Project	Gloucester Coal Seam Gas Project	From	Michael Ulph
Subject	Community Consultative Committee	Tel	4941 2841
Venue/Date/Time	Thursday 2 April Gloucester Country Club, 10am – 1pm	Job No	21/17714
Copies to	All attendees		
Attendees	Ian Shaw – AGL Lands Officer Toni Laurie – AGL Land and Approvals Manager Naomi Rowe – AGL Community Relations Manager Dr. Richard Evans – Independent Peer Reviewer, Principal Hydrogeologist (SKM) Ray Dawes - BGSPA Ed Robinson – Lower Waukivory Residents Group Gerald McCalden – The Gloucester Project Rod Williams – Community Representative Anna Kaliska – Mid Coast Water Clr Paul Hogan – Mid Coast Water David Mitchell – Avon Valley Landcare Clr Jerry Germon – Gloucester Shire Council Graham Gardner – Gloucester Shire Council Clr Tony McKenzie – Dungog Council Tim Hickman – Community representative Michael Ulph – GHD (Facilitator) Lilen Pautasso – GHD (Assistant Facilitator) Tim Weeks – Gloucester Shire Council (Observer)	Apologies	<b>Karen Hutchinson</b> <b>Lisa Schiff</b> <b>Terry Kavanagh</b>

Item	Action
<b>1. Introduction</b> <i>Welcome and Acknowledgement of Country</i>	
<b>2. Meeting agenda</b>	
▶ Introduction and welcome to new attendees	
▶ Disc

## Conceptual Model Water Balance

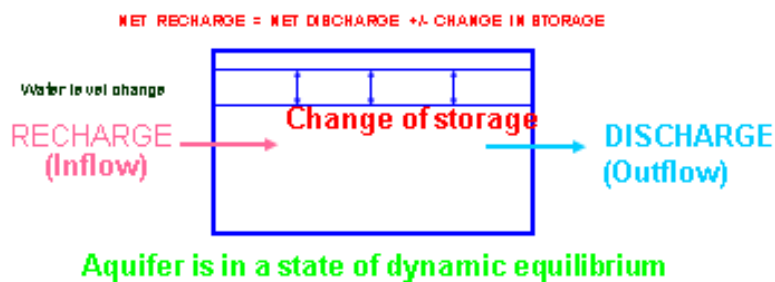
Rick: There are many different components to recharge and discharge. The +/- change of storage is how much the water in the aquifer is going up and down.

Rick: I'm being told the average is 200 but can go up to 400. How the differences in the water balance in the aquifer impact on recharge/discharge is important in this model. The major process that is occurring is ET (Evaporative Transpiration) – it will be about 80% of the water balance. That is the major impact at the surface in changes in discharge. The water balance is about understanding how the outflow changes. Unless we put numbers on outflow we can't have logical discussion on what the impacts are.

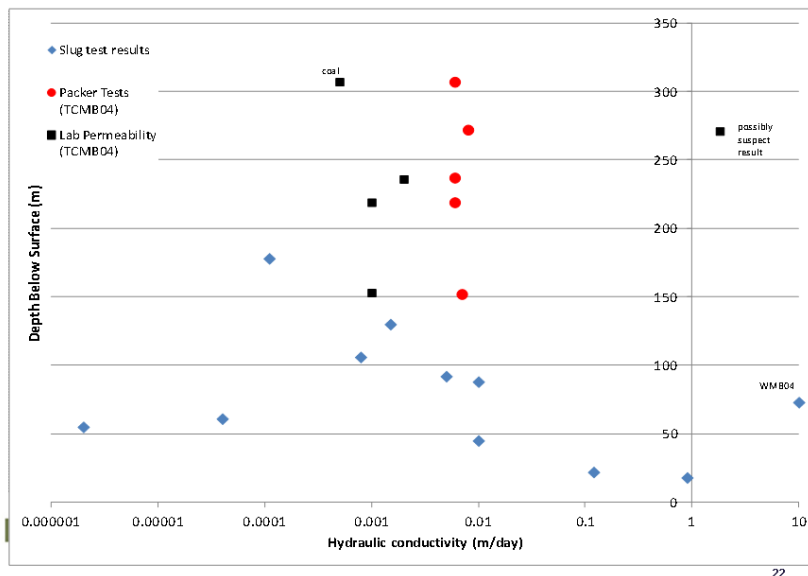
**CCC: Why are there such large variations?**

**CCC: My understanding is that you would want it to be closer to the Packer Test results. What about the 'possibly suspect result'?**

Rick: It is normal for large variations in the slug test, but what is causing the extremity results (e.g. 10, 0.000001) need to be explained in the report. Normally a conceptual model would discuss how this is going to be used and the distinction between the results needs to be made.

Rick: The 'possibly suspect result' is, in my opinion, absolutely normal because there are many factors that may have impacted on this (e.g. a spoiled sample). I wouldn't be concerned about this or draw any

The image shows three SKM presentation slides. The top two slides are side-by-side, and the third is centered below them. Each slide has a title 'Characterisation of fault zones' and a list of points.

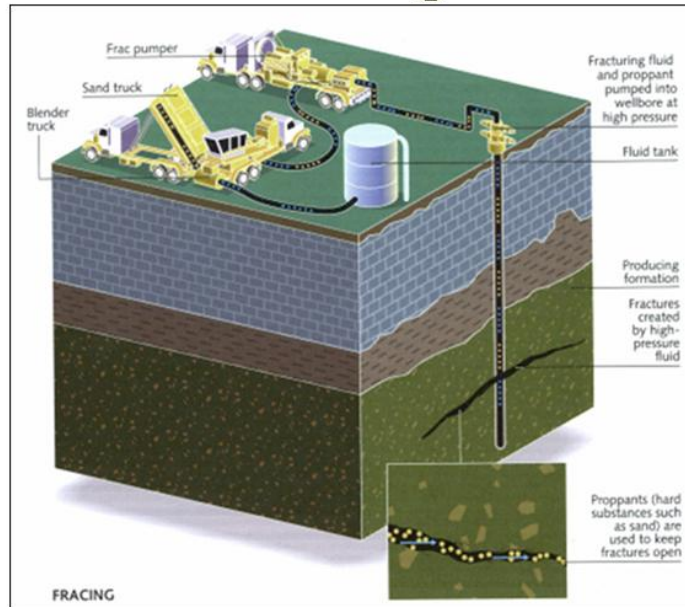
Rick: There is an inconsistency in the report which I have drawn out and we need a conceptual model that draws on all of the data not just general data. In most cases the fault zones tend to seal and reduce the conductivity – they reduce flow and constrain impacts and make them narrower. That doesn't mean to say that some faults are like this all the time. It seems to be that it is quite possible that you could get high conductivity in the fault zone and that the impacts are not what you expect them to be. It could result in impacts occurring in a different location and different speeds. The report says that there needs to be more work.

## CCC: How far could these faults run?

Rick: You could easily get a pressure transmission line at a couple of hundred metres. I've not seen any evidence of this happening here, there are lots of faults but they are not to a large scale. The jury is still out here and there is much more work required on faults.
